AGENDA
BIRMINGHAM DESIGN REVIEW BOARD
WEDNESDAY JANUARY 4, 2023
BIRMINGHAM CITY HALL, 151 MARTIN ST, COMMISSION ROOM 205, BIRMINGHAM MI *
******* 7:15 PM*******

SUBJECT: 34040 Woodward – Community Unity Bank – Design Review

The applicant has submitted a Design Review application for a sign and façade changes on an existing 1-story commercial building in the B2 General Business and MU-5 Triangle District Overlay zoning districts. The subject site is located on the east side of Woodward, north of Lincoln St.

EXTERIOR SCONCE

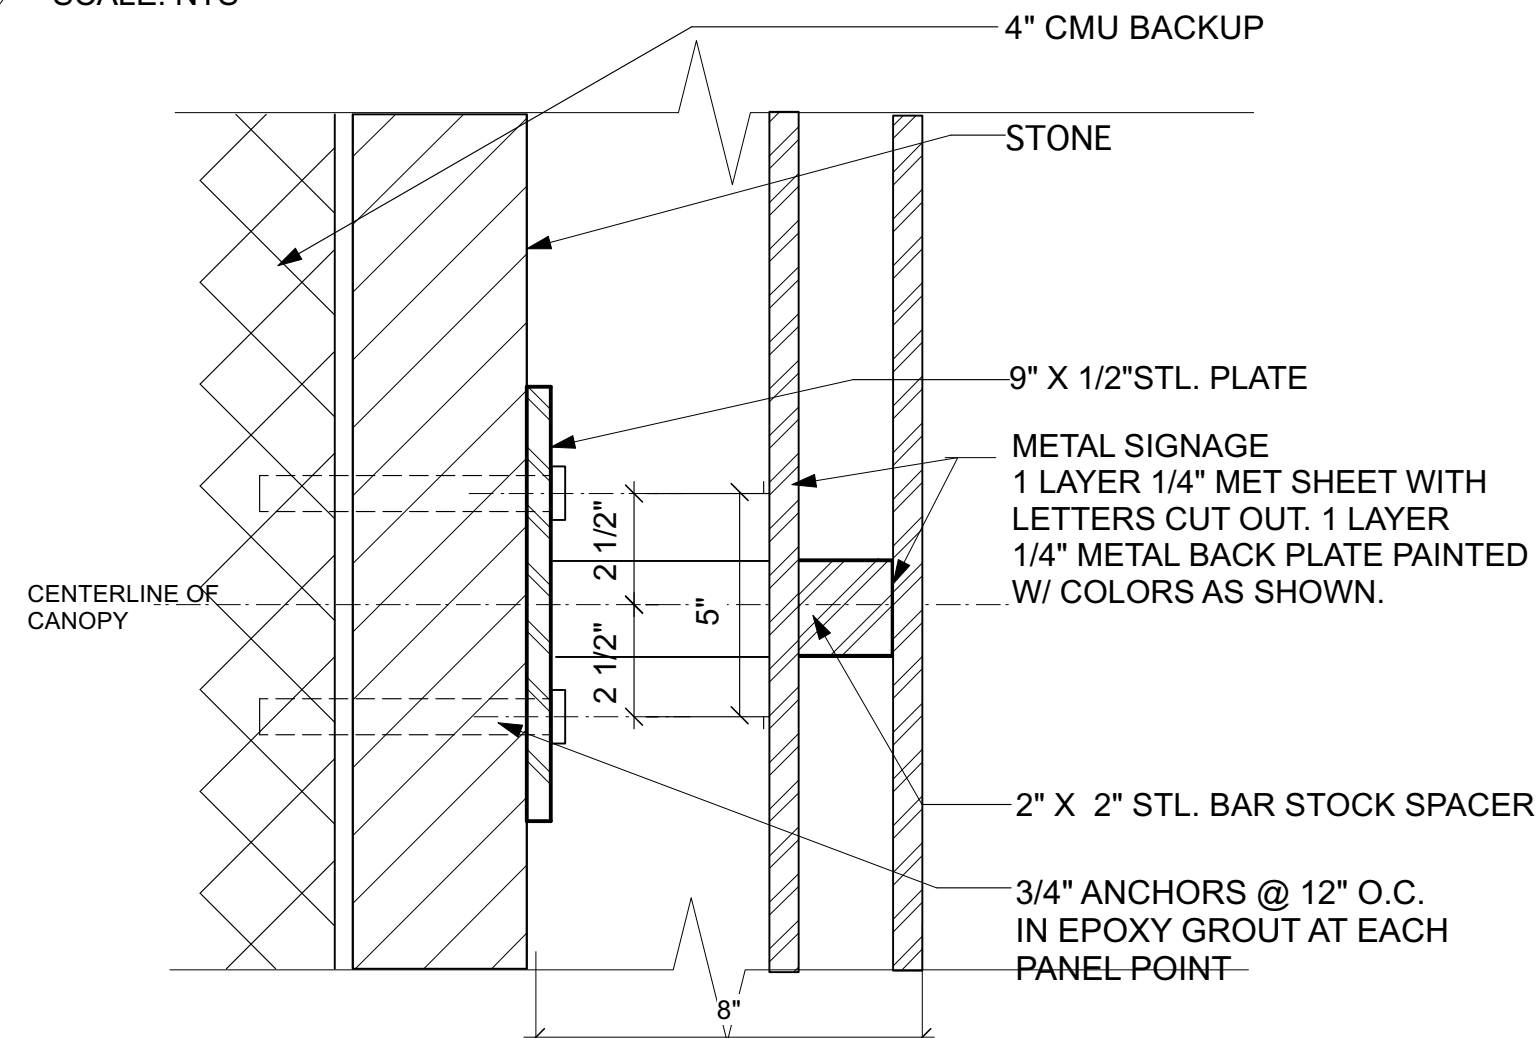
The 5 proposed Scott Arch. Lighting sconces will be replacing existing wall lights. The new wall sconces will be positioned lower on the wall. There are no dimensions included for height from grade, however the specification sheet shows the depth projection to be 4". **The applicant must submit revised plans to show the height from grade for the light fixtures.**

SOUTHWEST ELEVATION

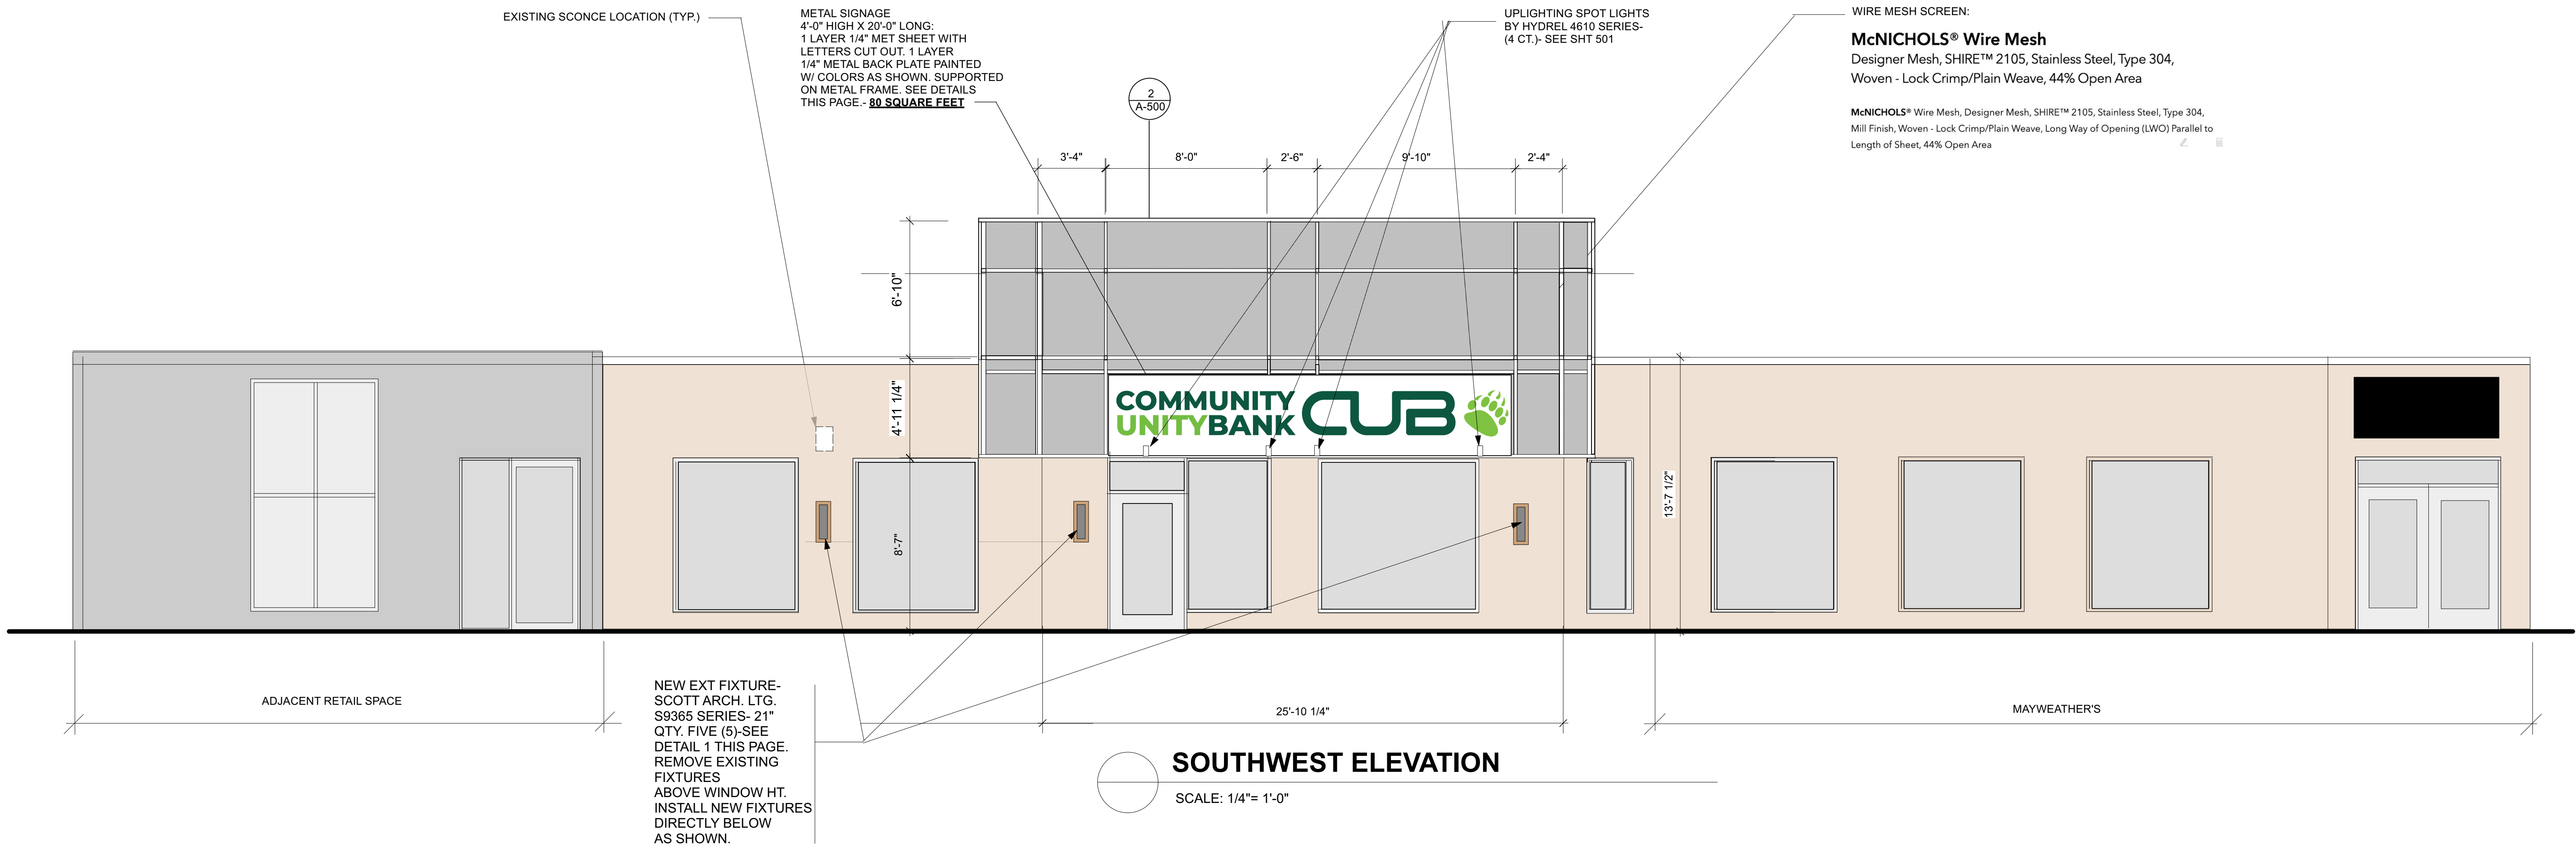
On December 7th, 2022 the sign and façade changes were reviewed at the Design Review Board. It was discussed by board members that it was difficult to gauge the aesthetic effect of the façade changes on the overall building by viewing the separate elevations. Board members requested that the applicant return with a rendering of the full building façade and postponed making a decision on the application to January 4th, 2023.

The total area of the proposed sign is 80 sq. ft. and the sign is proposed to be mounted in the sign band. The total linear building frontage for this tenant is 53.5 ft. on Woodward, which means that the total allowable combined sign area for this tenant is 80.25 sq. ft. The dimensions of the sign proposed are 4’ high by 20’ wide, however, these dimensions are not shown on the diagram and appear to be inconsistent with some of the other dimensions shown. **It is worth noting that the plans are inconsistent in some areas after revisions, which will need to be updated.**

The applicant has proposed new light fixtures on the building and site. The new light fixtures are summarized in the table below. A note about the proposed Scott Arch. Lighting; the plans state that 5 are propose, however, only 3 are shown on the plan. **The applicant should clarify the exact number of new Scott Arh. Lights proposed and submit revised plans to match.**

The proposed Hydrel spotlight light fixtures are not full cutoff as defined in Section 9.02. **Thus, the Design Review Board should discuss the proposed fixtures in regards to the six conditions listed above and determine if an exception will be granted.**

1. The applicant must submit revised plans with consistent signage details and all requested revised dimensions and lighting details;
2. The Design Review Board APPROVES the non-cutoff light fixtures pursuant to Article 4, Section 4.21 (D) of the Zoning Ordinance;
